U.S. Department  
of Transportation  
**Research and  
Special Programs  
Administration**

Ref. No.: 03-0093

This responds to your letter regarding requirements for an internal self-closing stop valve on a DOT 407 cargo tank under the Hazardous Materials Regulations (HMR; 49 CFR Parts 171-180). Specifically, you asked whether a "swing check valve" as shown in the enclosed diagram would be acceptable to meet the "internal self-closing stop valve" provisions in §178.345-11(b).

Re: Formal interpretation request

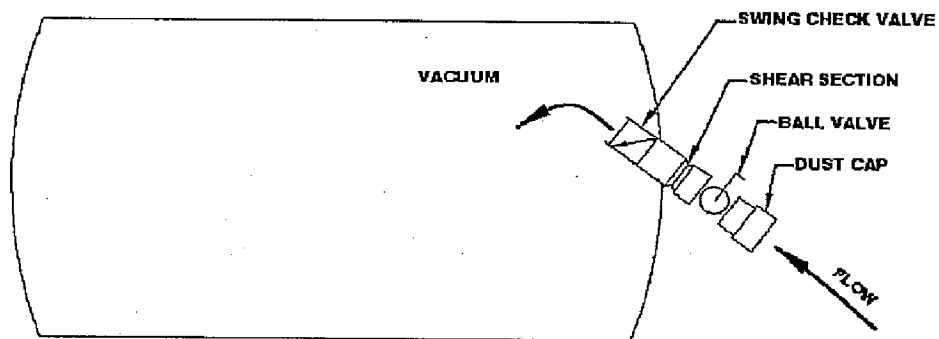
1. This section states, "Each cargo tank loading/unloading outlet must be equipped with an internal self-closing stop-valve...". By definition from section §178.345-1 (c), this type valve must be shut by self stored energy within the tank. Therefore, it is my professional opinion that a swing check valve (as shown below) will meet the intent of this regulation. Please confirm my interpretation.

An internal self-closing stop valve is a self-closing stop valve designed so that the self-stored energy source is located inside the cargo tank or cargo tank sump, or within the welded flange, and the valve seat is located within the cargo tank or within one inch of the external face of the welded flange or sump of the cargo tank. The regulations do not prohibit a design of the type, such as the "swing check valve," shown in the enclosed diagram if it meets all of the requirements for an "internal self-closing stop valve," specified in §178.345-11(b). You did not provide sufficient information in your letter or a detailed drawing of the components of the "swing check valve" for us to determine if it complies with the requirements in §178.345-11(b).
